# E Renfro QuikTrip – Site Plan

## Item for approval:

Site Plan with waivers  
(22-106)

## Site Plan Summary:

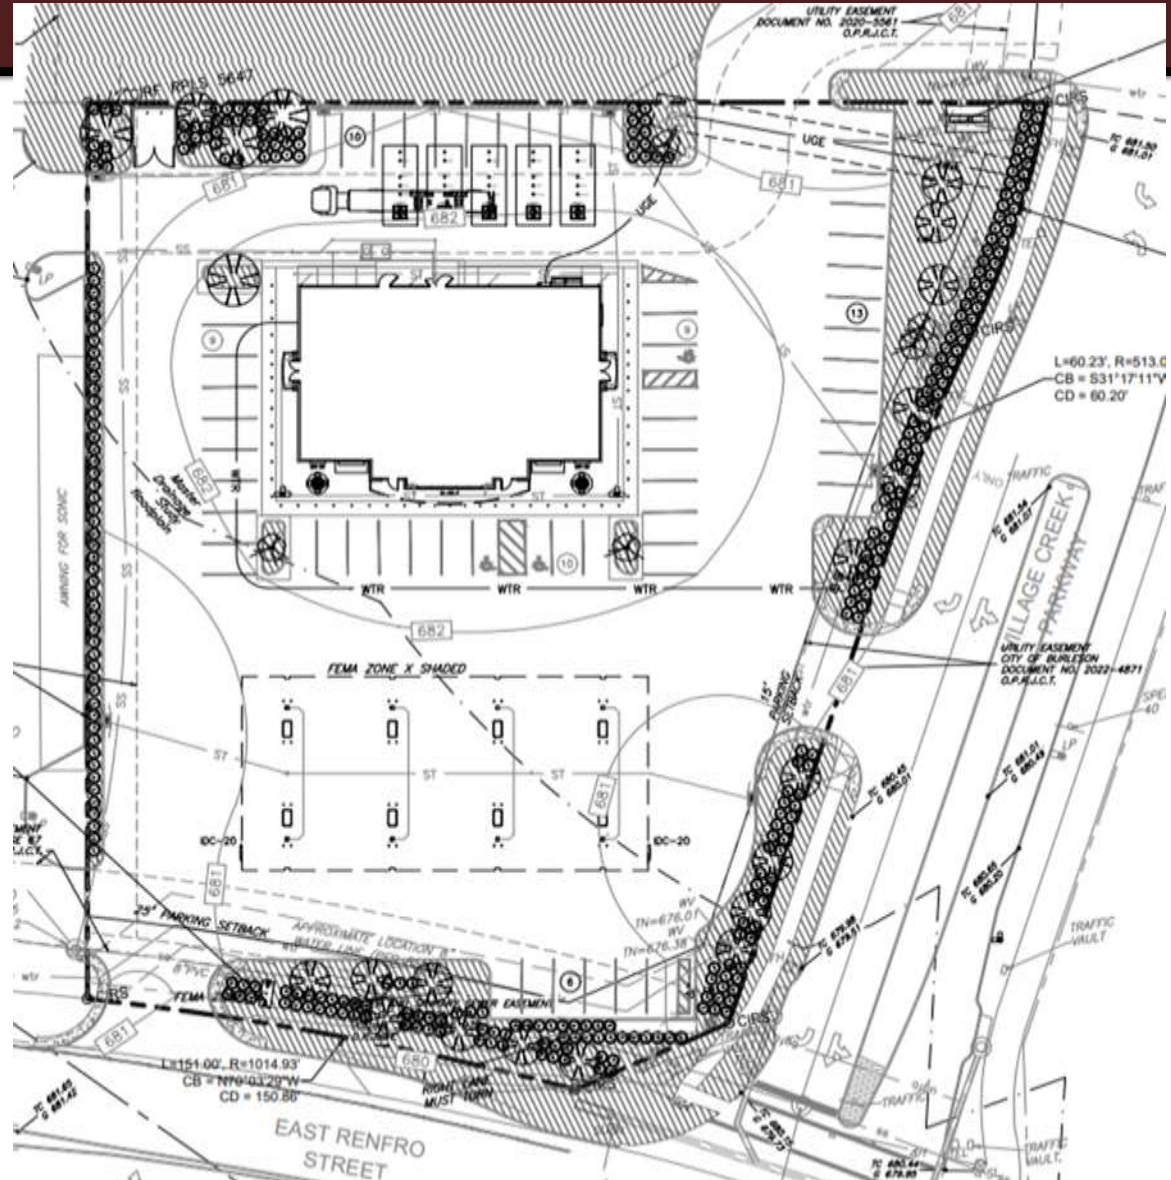
- 5,312 SF Building
- 20 feet in Height -Single-story
- Use – Convenience store with Automobile fuel sales

## Waivers requested:

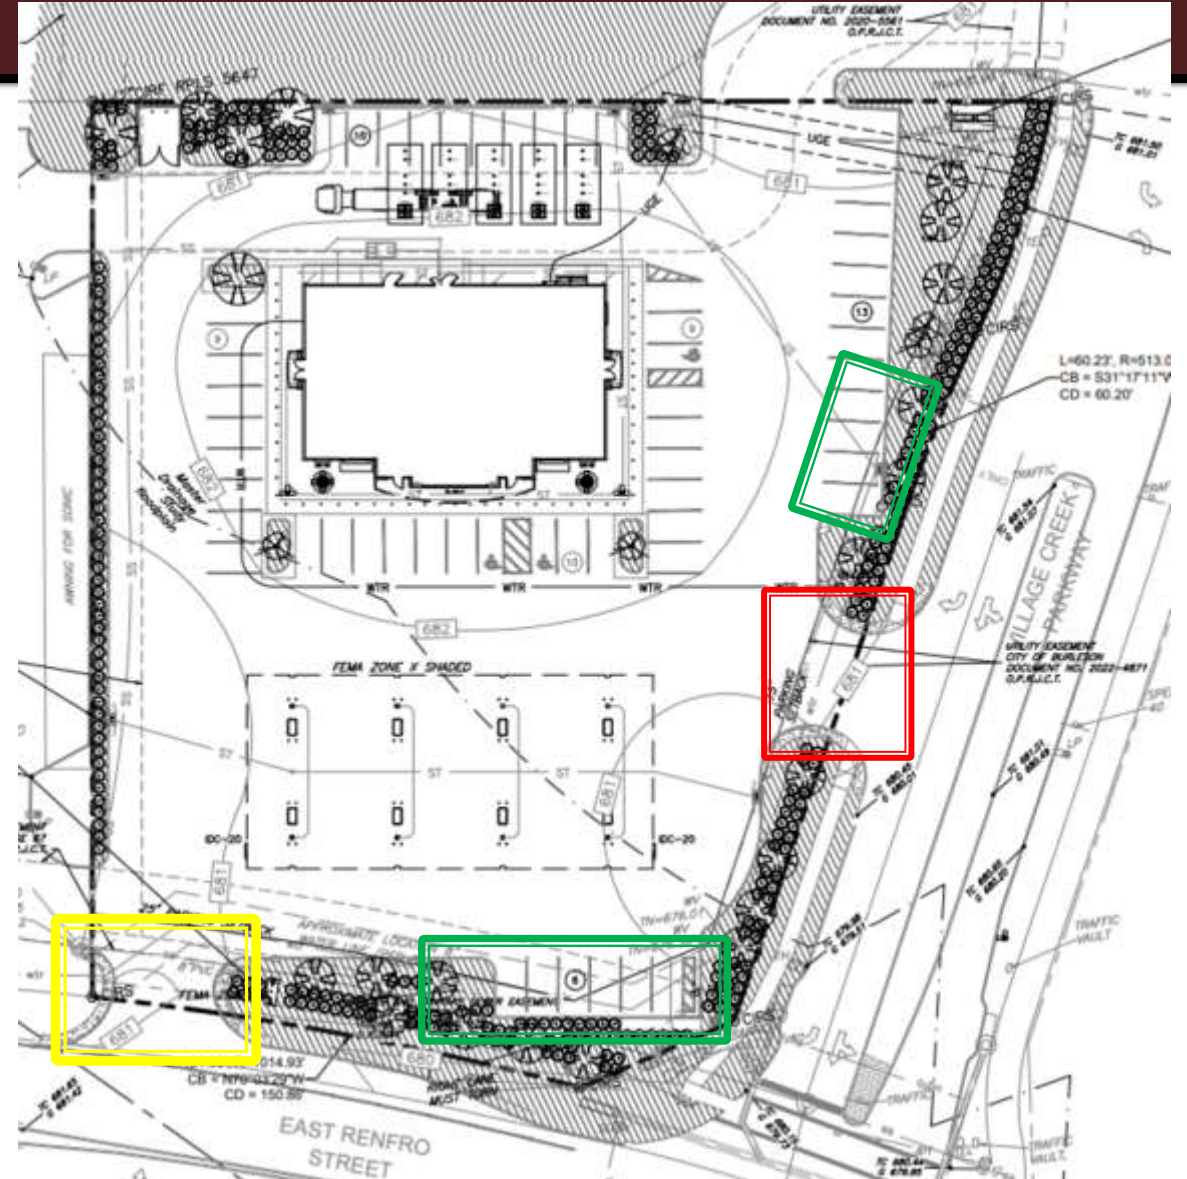
- Parking setback of 25 ft. along E Renfro and 15 ft. along Village Creek Pkwy (IH35 overlay requirement)
- Staff supports - Parking spots will be landscaped between headlights and street (shown in green)
- Drive (access) spacing of 180 feet.[Engineering Design Manual requirement] along Village Creek Pkwy
- Staff does not support reducing the minimum required spacing to 143 ft., based on proximity to E Renfro and existing access to the site (shown in red)

A separate variance request has been submitted to TxDot (shown in yellow) for E Renfro

Recommend unanimous approval of the site plan with a waiver to the parking setback and disapproval of the drive access spacing variance

Approval of a commercial site plan with a waiver to the IH35 parking setback requirement (Case 22-106).

Disapproval of the request for a waiver to the driveway spacing requirement along Village Creek.

## Landscaping

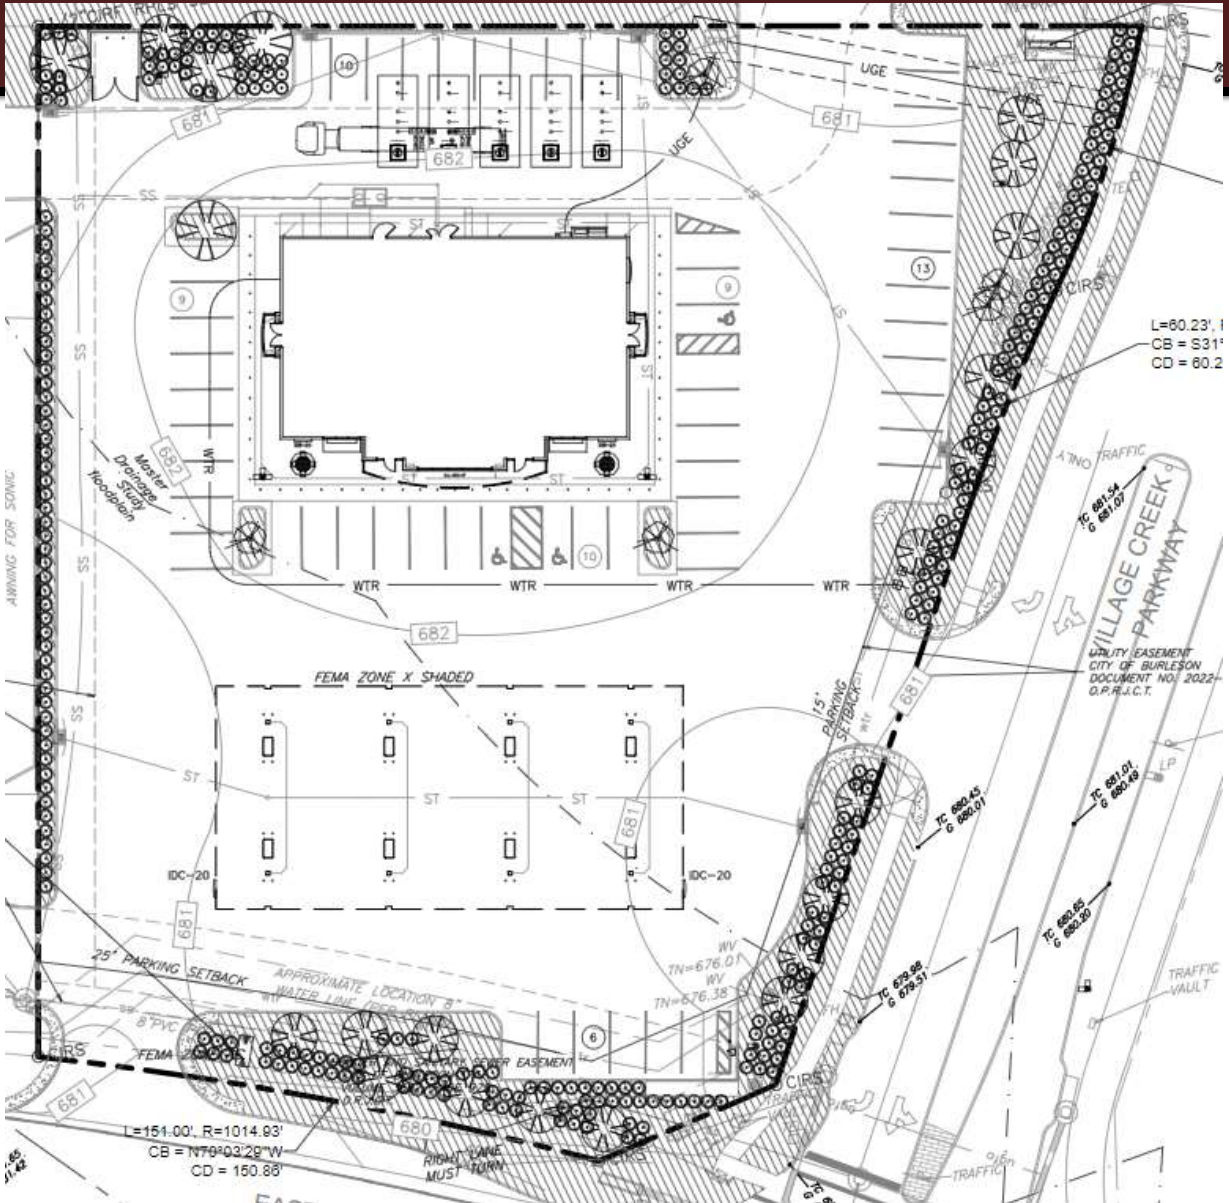
Required 13,869 SF  
Providing 13,873 SF
